NOTICE OF PROPOSED CHANGE IN PROPERTY

Petition: x482

B						REQUEST FOR TRANSFER OF ENCROACHMENT INTO BOTH E. GRAND RIVER AND LIBRARY AVE. WITH EXITING BASEMENT AREAWAYS 10 FEET INTO R.O.W. (With Vaults Below Grade)	CITY OF DETROIT CITY ENGINEERING DEPARTMENT SURVEY BUREAU	
A					JOB NO. 01-01			
DESCRIPTION		DRWN	CHKD	APPD	DATE			DRWG. NO. x482 (aka x197)
REVISIONS								
DRAWN BY		CHECKED						
JK / WLW								
DATE		APPROVED						
04-22-15

PETITION NO. 482
 HONIGMAN
 C/O CURIS1274 LLC
 39400 WOODWARD AVE. SUITE 101
 BLOOMFIELD HILLS, MICHIGAN 48304
 C/O AARON BASS ESQ.
 PHONE NO. 248 566-8609

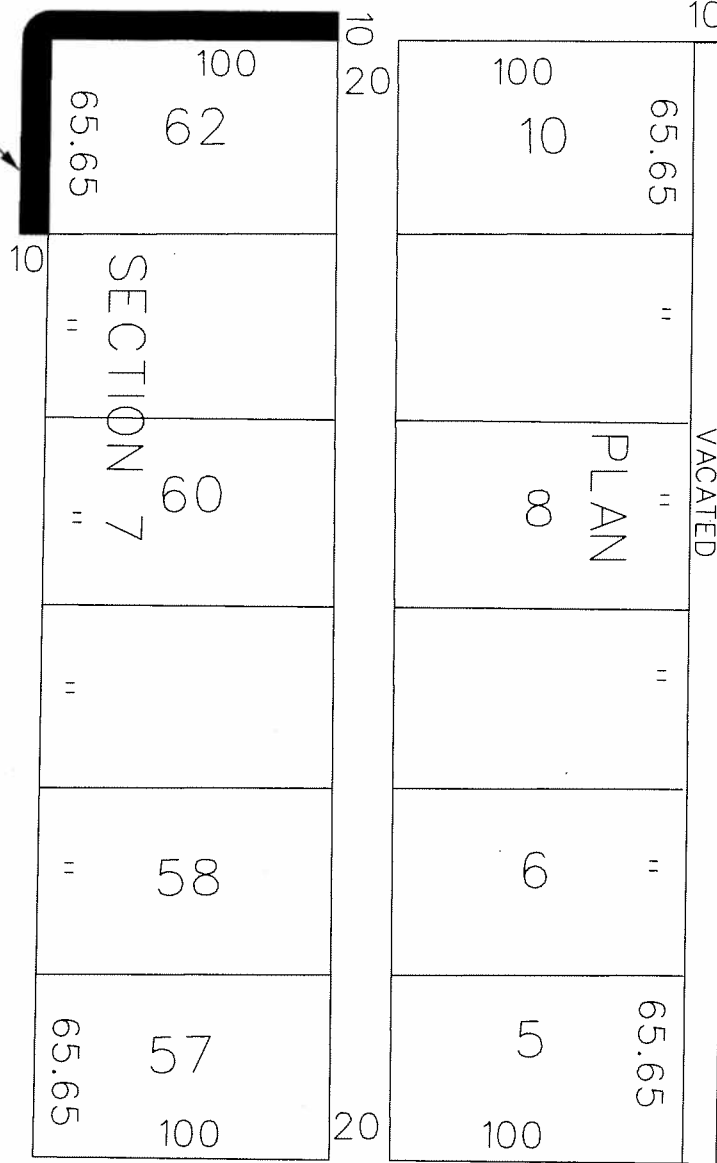
- Not Involved
- Involved; but asking you to hold action on this petition until further notice.
- Involved; but no objections to the property change.
- Involved; but no objections to the property change... provided as easement of the full width of the public right-of-way (street, alley or other public place) is reserved.
- Involved; the nature of our services and the estimated costs of removing and/or rerouting such services are: *If excavation or major work is being performed then a CWO quote must be acquired. We do have conduit with copper and fiber in the manholes.*

WE DO HAVE CONDUIT AND MANHOLES
 NEAR THE PROPOSED WORK. ANY QUESTIONS
 PLEASE CALL 313 240-5482
 KEVIN LOGAN
